**Subject: Annual Inspection Report  
Ashland/Lineville Municipal Airport**

## ANNUAL INSPECTION REPORT

ASHLAND/LINEVILLE AIRPORT

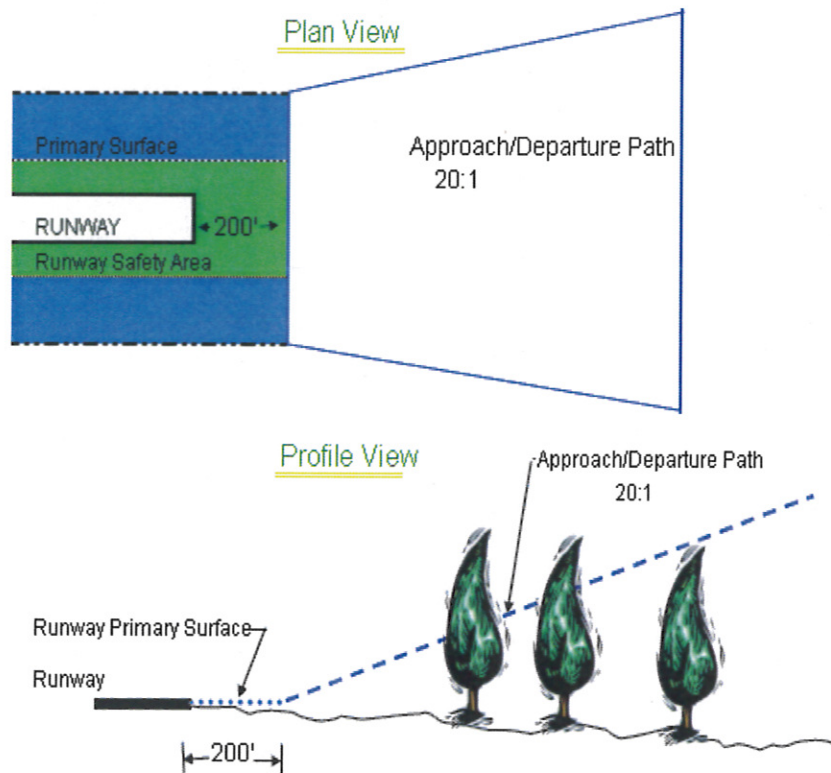
- The wind cone fabric was torn and faded (Photo # 4).

- Wind cone fabric should be replaced.
